Subject: Comments Concerning the Two Rivers Wind Project, Carbon County, Wyoming

RE: Public Comment: Draft Environmental Assessment for the Two Rivers Wind Project – DOI-BLM-WY-D030-2021-0005-EA

Figure 2. Proposed Two Rivers Wind Project in relations to Wyoming Game and Fish Department-identified seasonal ranges for antelope, which is almost entirely within annual Antelope Crucial Winter/Yearlong habitat.

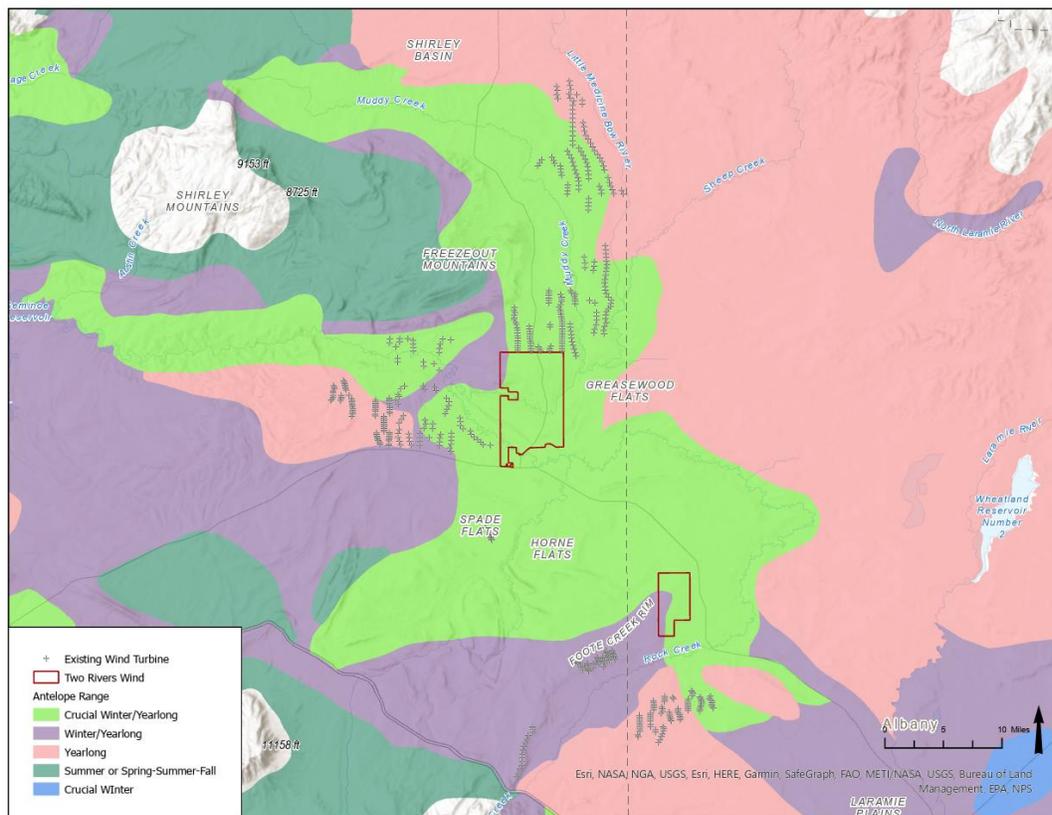
Review of seasonal big game range data by Wyoming Game and Fish Department (WGFD) shows how the proposed project is located in an epicenter of important big game (antelope, deer, elk) ranges. Both project areas (Phase I-III, Phase IV) intersect and are surrounded by WGFD-identified *Antelope Crucial Winter/Yearlong habitat* and *Winter/Yearlong habitat*. The modifier Crucial denotes “the determining factor in a population's ability to maintain itself at a certain level (theoretically at or above the WGFD population objective) over the long term.”²⁶ All phases of the proposed Two Rivers wind project are almost entirely within annual *Antelope Crucial Winter/Yearlong habitat* (Figure 2). For all three ungulate species, the crucial seasonal habitat component is availability of areas with less snow accumulation, where browse and shelter are available. For Elk, Phase I-III are located in *Yearlong habitat* in the area north of Greasewood Flats and the entirety of Phase IV is in *Winter/Yearlong range* (Figure 3). For Mule Deer, all phases are in a combination of *Winter/Yearlong* or *Yearlong* (Figure 4).

Figure 4. Proposed Two Rivers Wind Project in relations to Wyoming Game and Fish Department-identified seasonal ranges for mule deer. All portions of the project area are within a combination of *Winter/Yearlong* or *Yearlong* habitat.

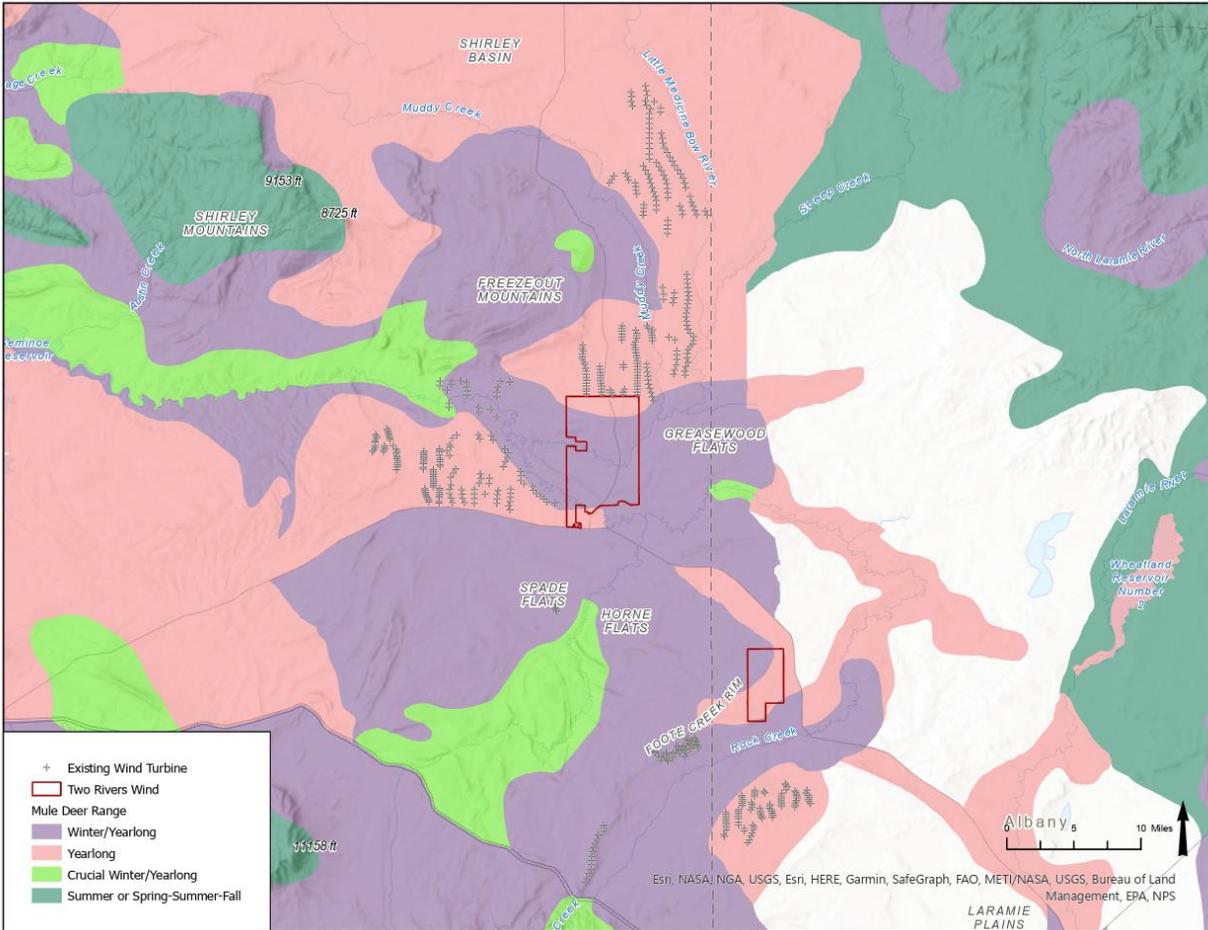
Thus, big game are plentiful at all times of the year in the area proposed for the Two Rivers wind project. In regards to Golden Eagles (and Ferruginous Hawks²⁷), winter is the time of greatest carcass availability for scavenging, especially as gut piles from hunting activity become available just as other food sources are becoming scarce. Using combined hunter harvest rates for all three big game species into single layer created by Lau et al. (2016), which was created to represent lead poisoning risk for Golden Eagles, the area encompassed by the proposed wind project has a medium-high level of harvest density (Figure 5)²⁸.

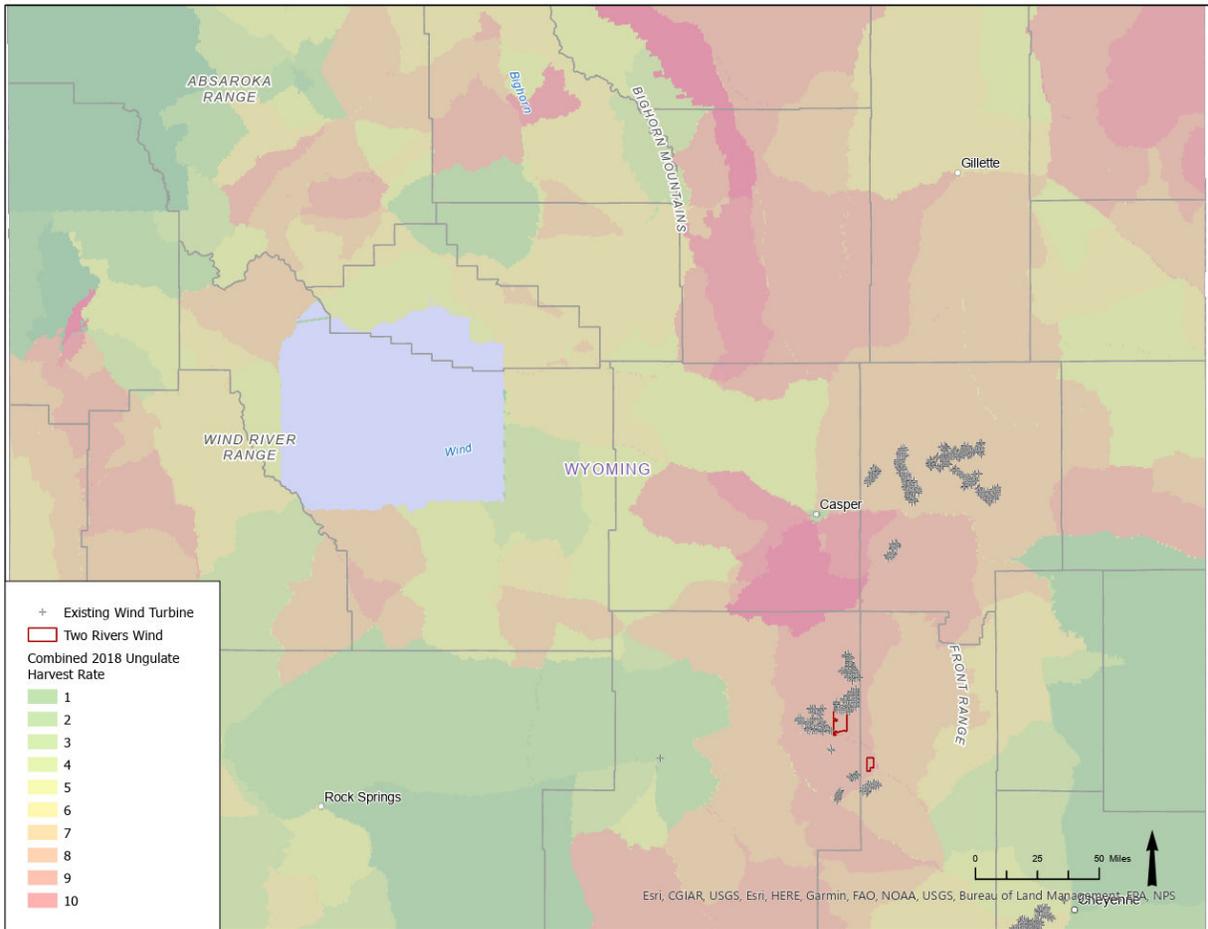
Golden Eagles rely on carrion from hunter gut piles during the winter and experience elevated lead exposure levels during December when these food resources are most available²⁹. As shown in the Wyoming and Uinta Basins Golden Eagle Conservation strategy (see Figure 4.14, inserted below, from Wallace et al. 2019)³⁰, the overlap of high hunter harvest rates in oranges and high breeding and wintering habitat use in greens is shown for Golden Eagle breeding and winter habitat in shades of purple on the left and right maps, respectively. The Two Rivers proposed project areas (black stars) are again both located in areas of high hunter harvest rates and high eagle habitat quality.

Figure 4. The 2019 to 2021 home range/territory of Eagle 152367 just a few miles W of the proposed Two Rivers wind project area. Slide depicts how extremely dense breeding adult activity areas typically are, and again, with little overlap between breeding pairs.

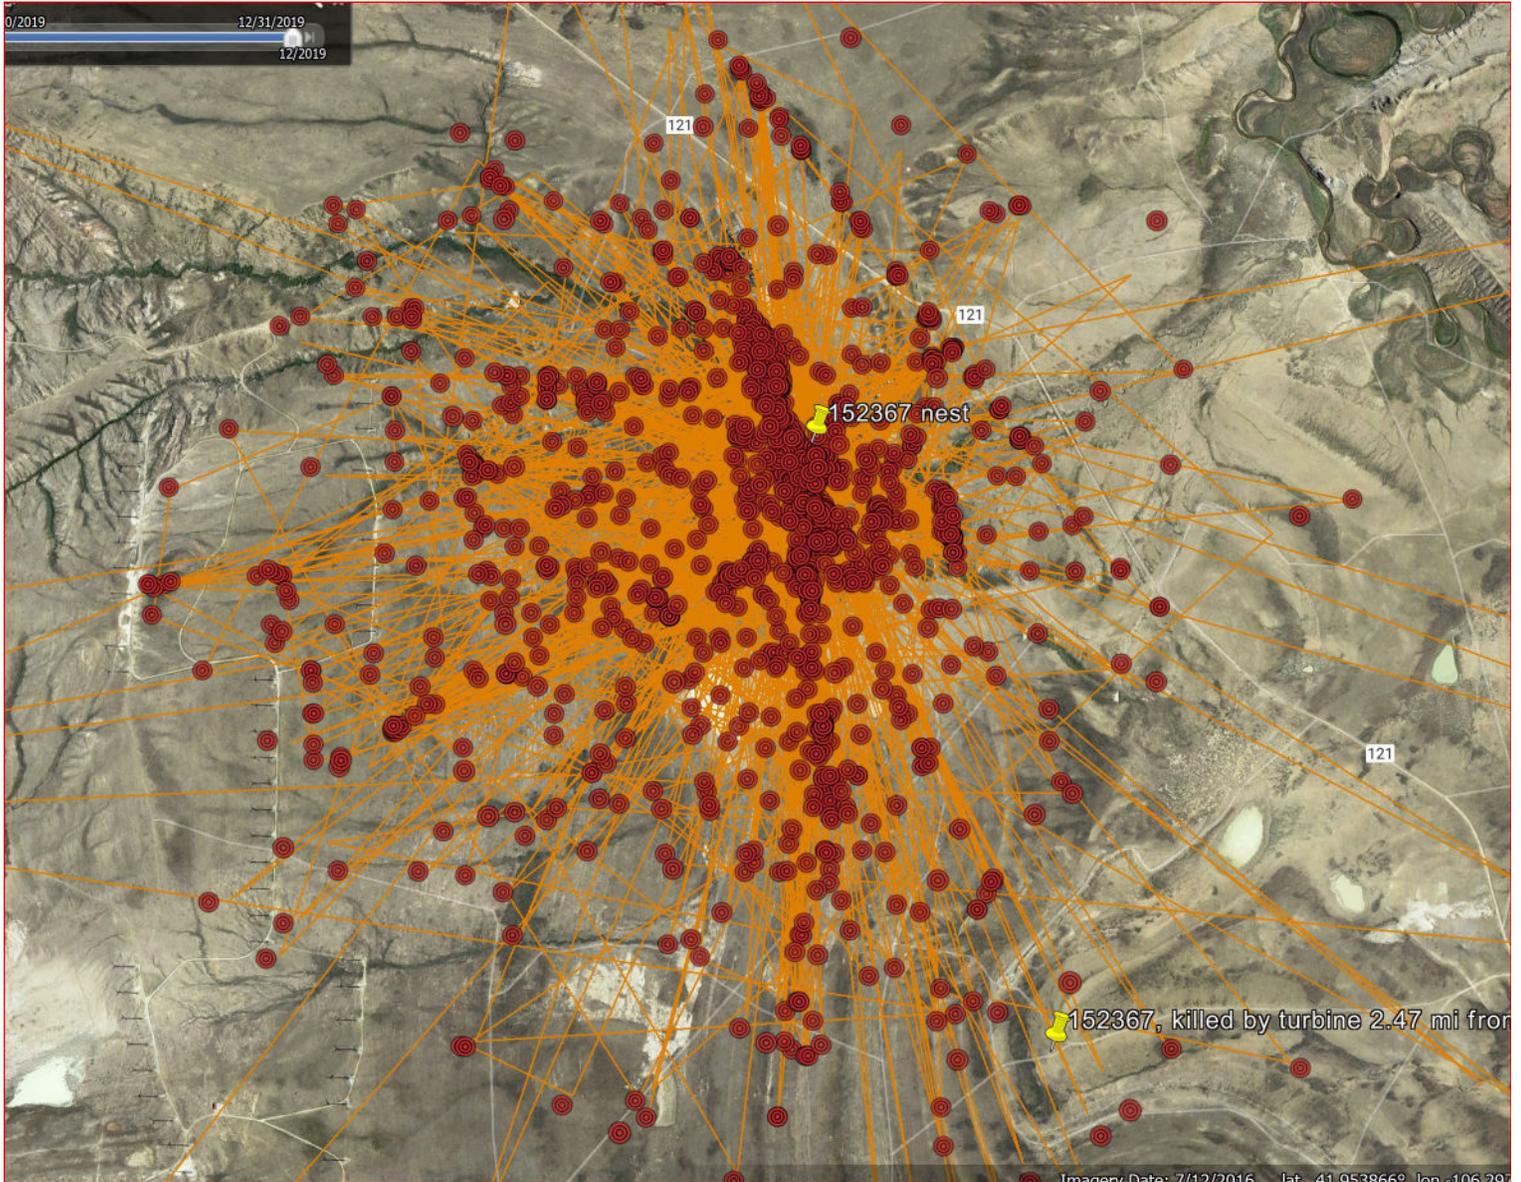
A breeding, adult male golden eagle (#152367) I caught and tagged November 11, 2016, and which successfully reared young 4 out of 5 years, was killed by an Ekola Flats turbine 2.47 miles away from his nest, and just months after the Ekola Flats project became operational (Figures 4 and 7). Additionally, a well-established territory with excellent nests to the NW of the Ekola Flats nest has been occupied for the last 6 years but has not successfully produced young (Figure 8)! Although now impossible to prove, I am convinced this nesting territory has been compromised by the Seven Mile wind project. Two adults, a female and a male were killed in 2009 and 2010, approximately 2.2 miles and 2.3 miles, respectively, from the close cluster of 4 nests. It is important to understand that the takings of breeding adults will never likely to be a one-off occurrence. The continued presence of the other adult and available nests will attract replacement mates. This is what happened to the Ekola Flats nest in 2022. A replacement male took possession of the territory and nest and the pair successfully fledged 2 eaglets in 2022.
